**KITIMAT RIVER HATCHERY**  
 CONTRACT NO F1700-130721  
 AERATION TOWER MODIFICATIONS

**PIPING AND EQUIPMENT PLAN**

**PIPING SECTIONS**

PIPING PLAN AT EL 20.0  
 SCALE: 1 : 33 1/3

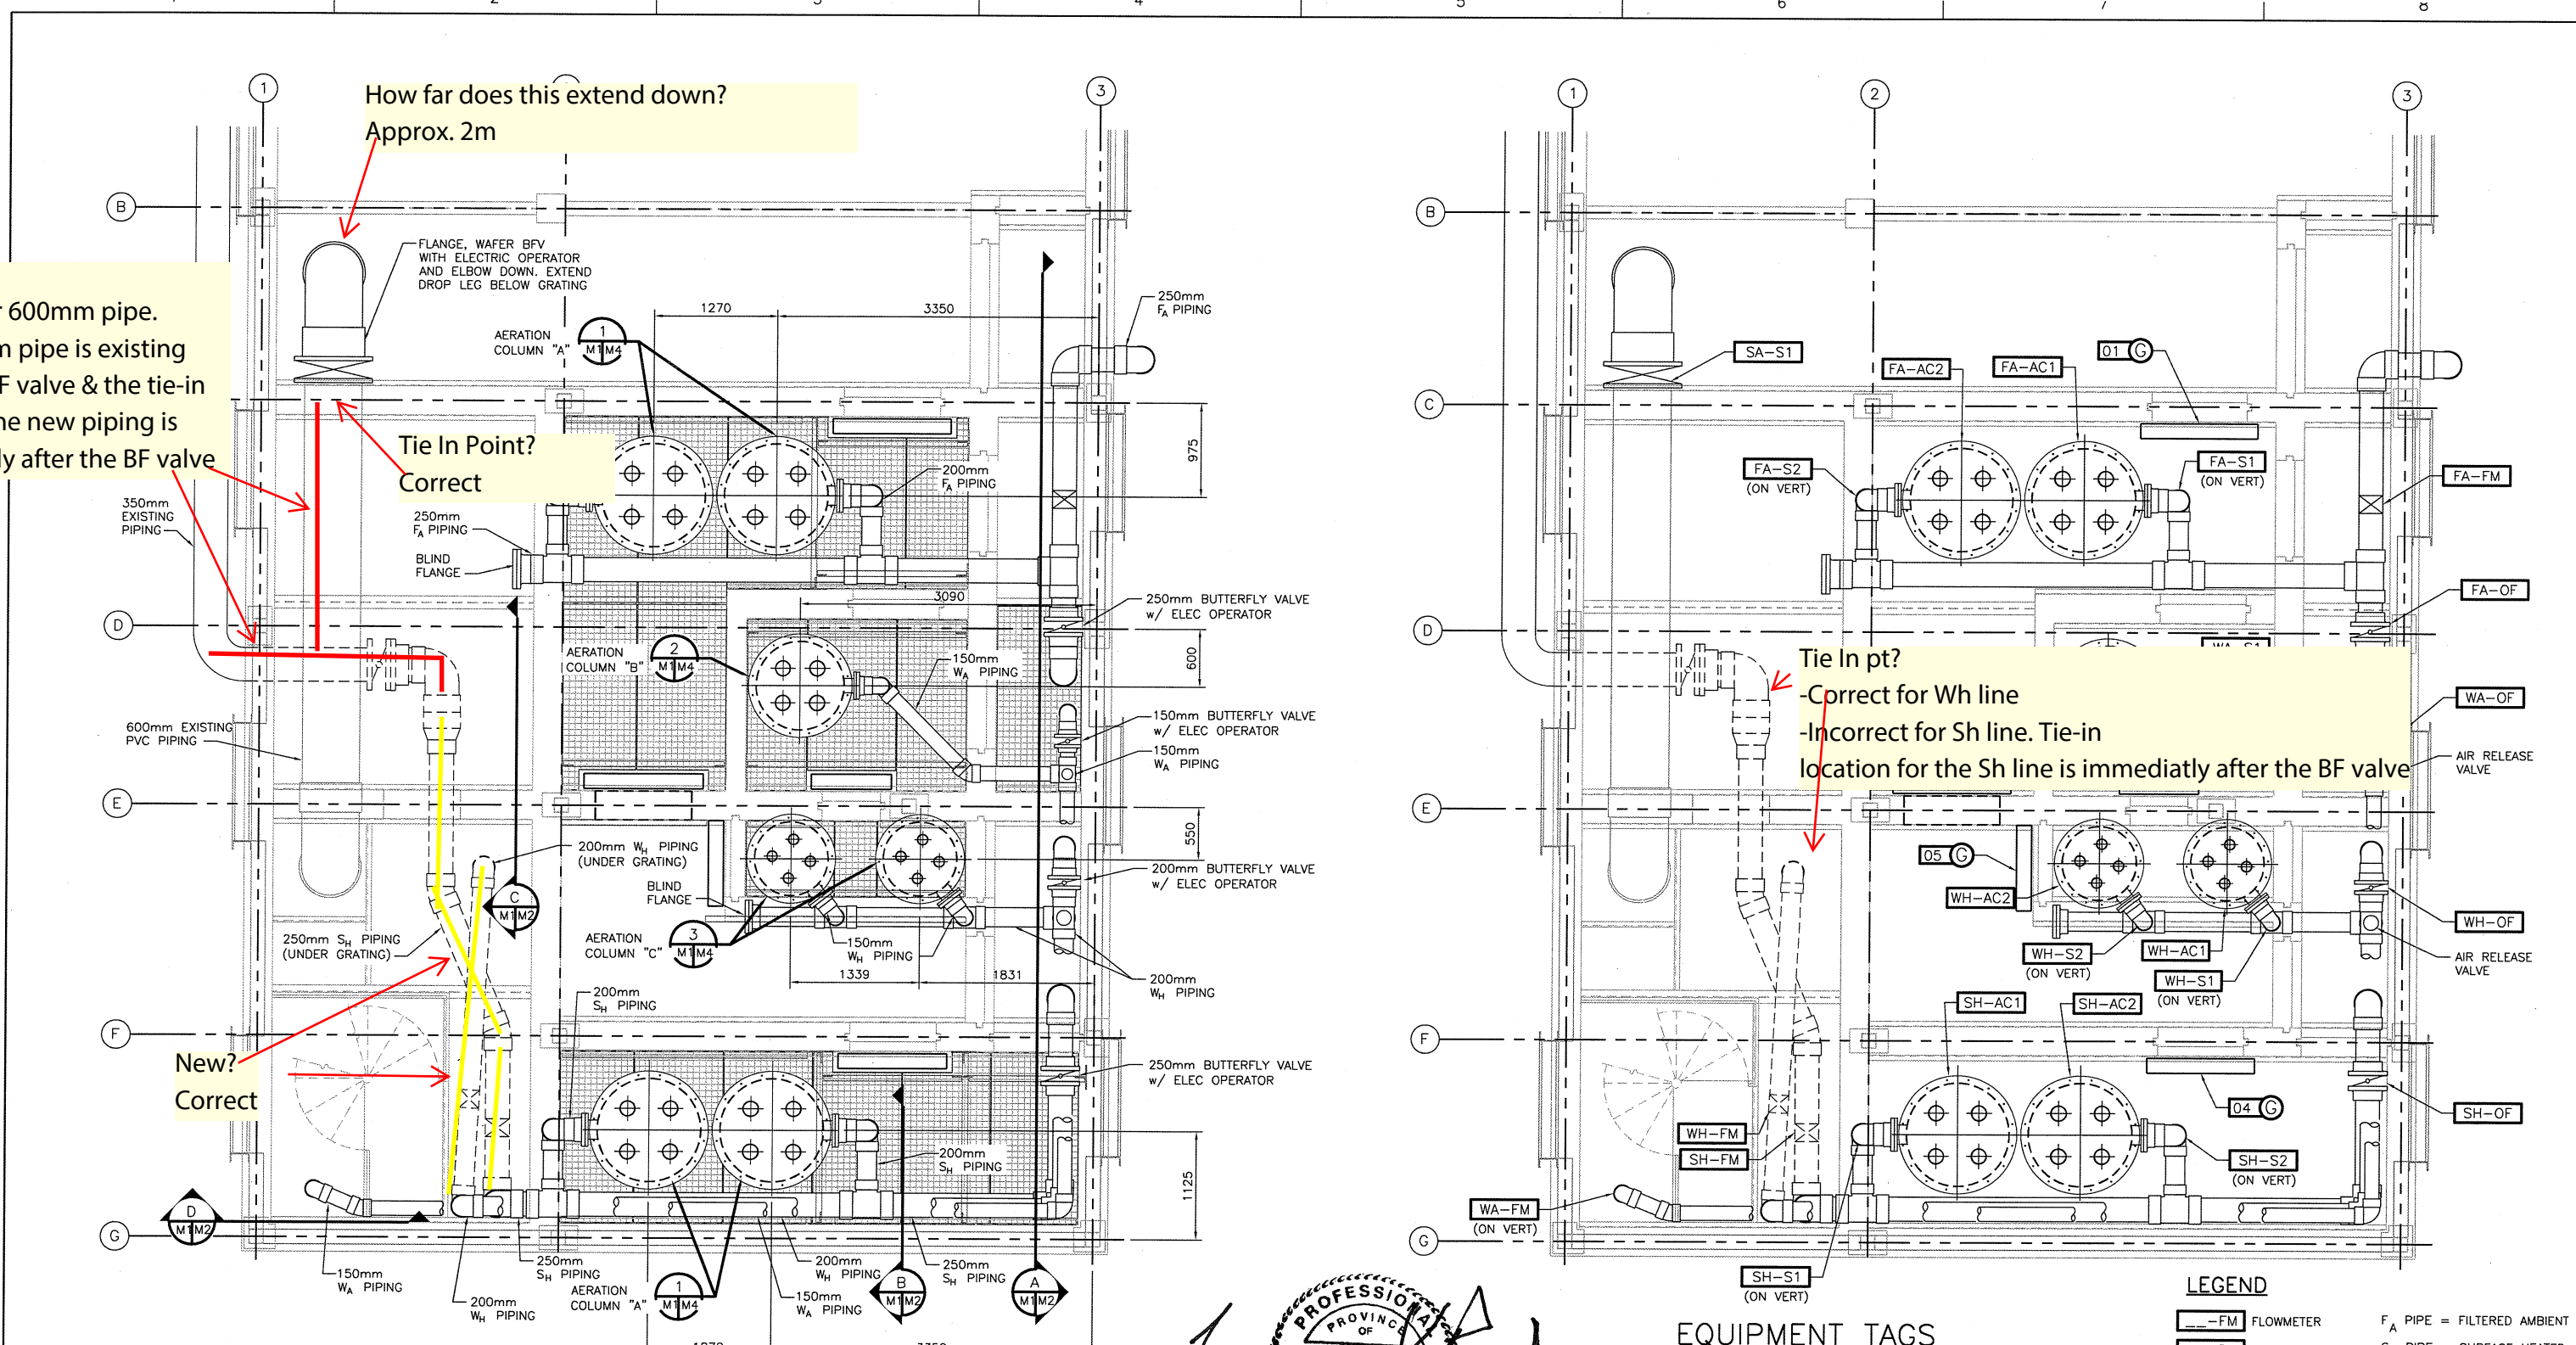
Exists?  
 -Correct for 600mm pipe.  
 -the 350mm pipe is existing up to the BF valve & the tie-in point for the new piping is immediately after the BF valve

How far does this extend down?  
 Approx. 2m

Tie In Point?  
 Correct

New?  
 Correct

Tie In pt?  
 -Correct for Wh line  
 -Incorrect for Sh line. Tie-in location for the Sh line is immediately after the BF valve

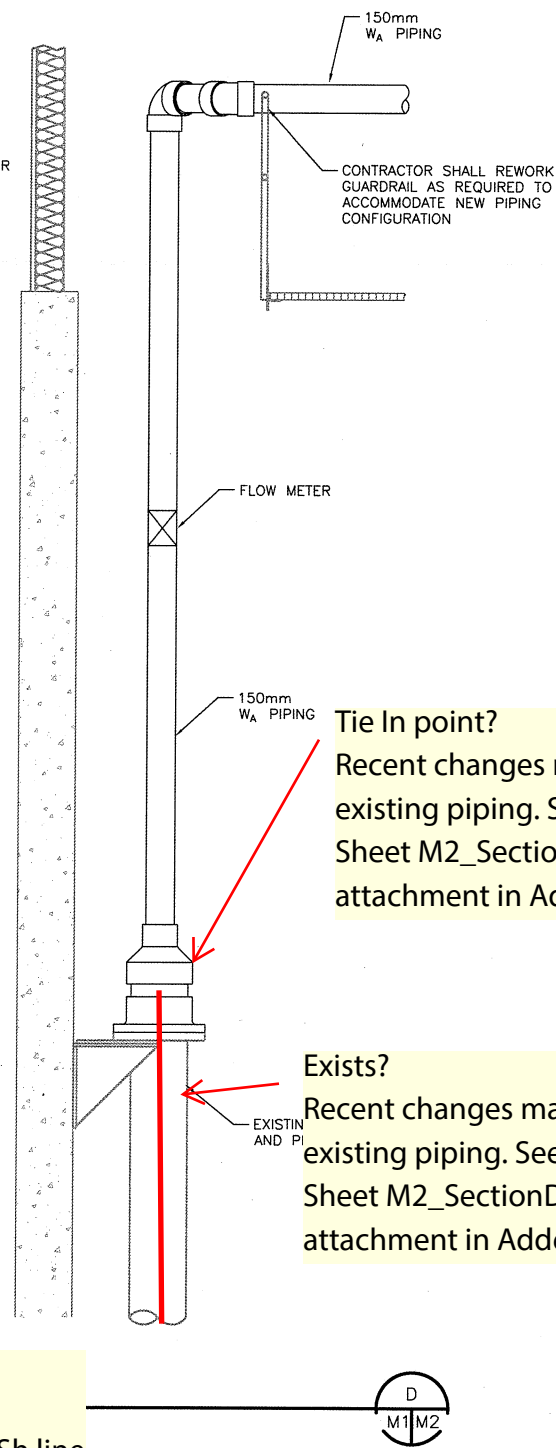
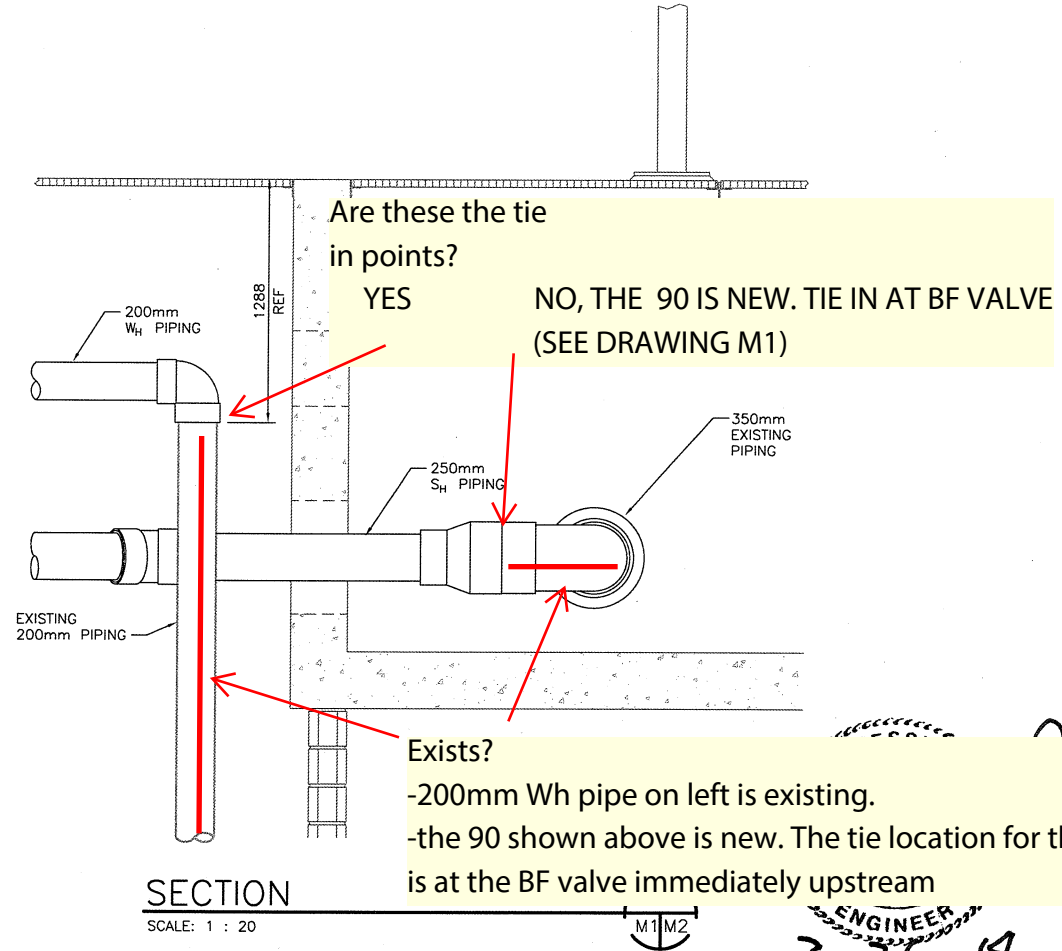
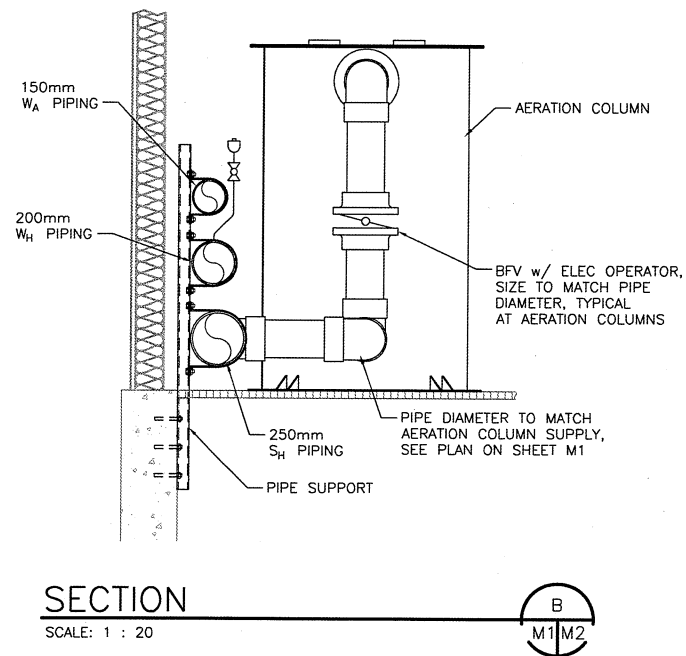
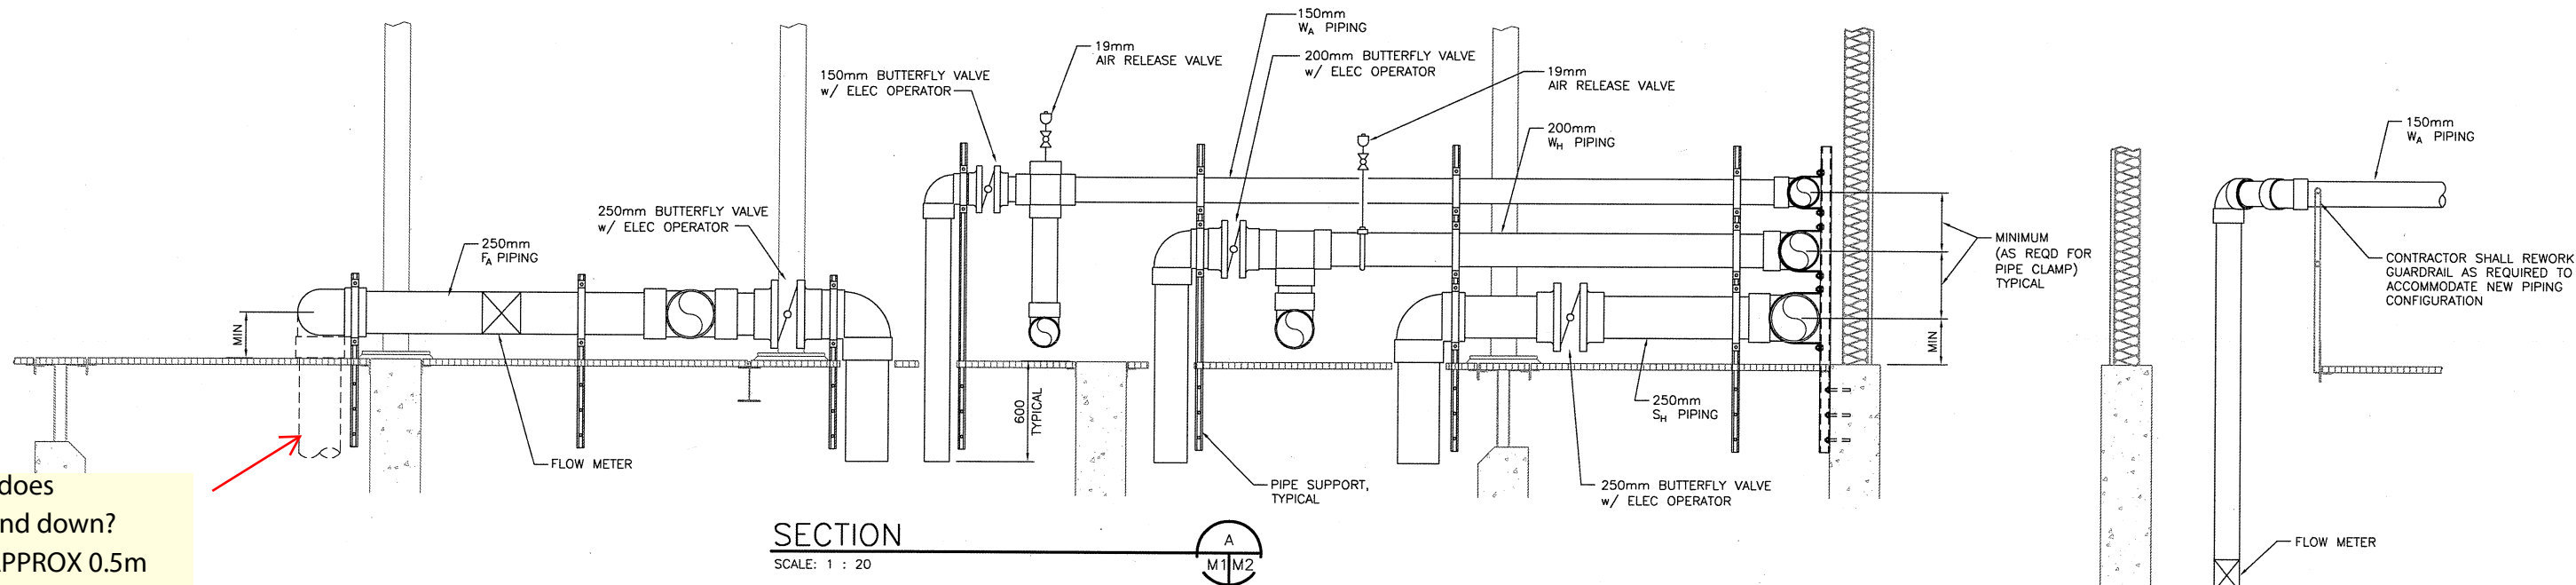
How far does this extend down?  
APPROX 0.5m

Are these the tie in points?  
YES NO, THE 90 IS NEW. TIE IN AT BF VALVE (SEE DRAWING M1)

Tie In point?  
Recent changes made to existing piping. See "KFDS-Sheet M2\_SectionD.pdf" attachment in Addendum

Exists?  
Recent changes made to existing piping. See "KFDS-Sheet M2\_SectionD.pdf" attachment in Addendum

Exists?  
-200mm Wh pipe on left is existing.  
-the 90 shown above is new. The tie location for the above Sh line is at the BF valve immediately upstream
